Proposed Large-scale Residential Development,  
Sarsfield Road, Wilton, Co. Cork

Quality Audit Report

January 2025

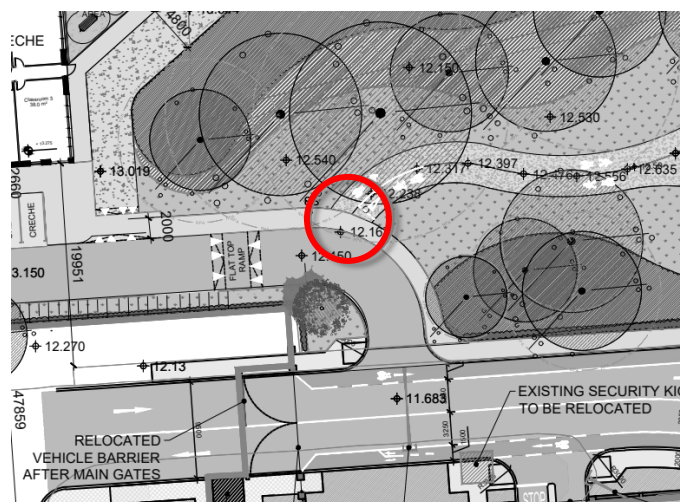
No provision for cyclists to exit the shared surface onto the adjoining internal road. This may result in cyclists continuing along the footpath or entering the carriageway off the raised kerb at an unsafe location. Both of these scenarios could result in a collision between a cyclist and a pedestrian or a cyclist and a moving vehicle.

The shared surface will be constructed at grade with the adjoining footway. No information to visually impaired users of the changed use across these pathways is shown in the drawings.

There is a risk that visually impaired users may enter the shared surface without due care and attention.

It is unclear if any cycle paths are to be covered. Residents in the apartments or employees working in the creche, may be discouraged from using cycle stands if they believe the locations are unsafe, or if their bicycle will be exposed to the weather. This may discourage users from choosing cycling as a sustainable form of transport

Provide a ramped exit to/from the shared surface for cyclists to ensure safe connectivity to the existing cycle lane along the ESB Access Road, with appropriate signage, in accordance with the relevant design standards.

Tactile paving should be used at crossings and at entry to shared cycle/pedestrian areas throughout the development to clearly warn visually impaired pedestrians when approaching a roadside crossing or a shared space.

Provide a portion of covered/secure cycle stands where possible throughout the site.
